RFP SECC0209-1

Scott Emergency Communications Center (SECC)

Public Safety Communications Systems and Law Enforcement Records Management, Field Reporting and Jail Management Systems

Addendum #1: Answers to Proposer Questions – Issued 03/12/2009

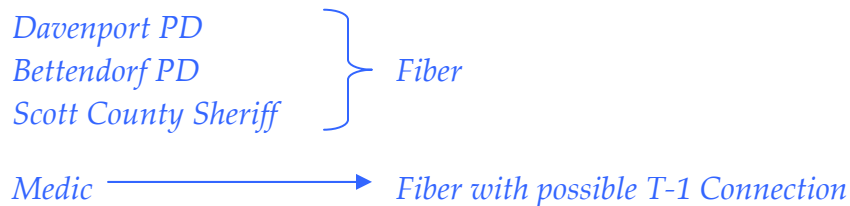
23. Can a diagram of the network as it relates to this project be provided? If so, this should include the connections related to cities and counties.

24. On page 20, of the RFP document, Section 4.4: Does this list of dispatched agencies reflect all remote sites to be served by the proposed system? If not, can a complete list of remote sites be provided?

- a. What are the bandwidth specifications of the network connections to these remote locations?

The list of dispatched agencies reflects the remote sites. Please refer to Appendix D for complete system volume requirements.
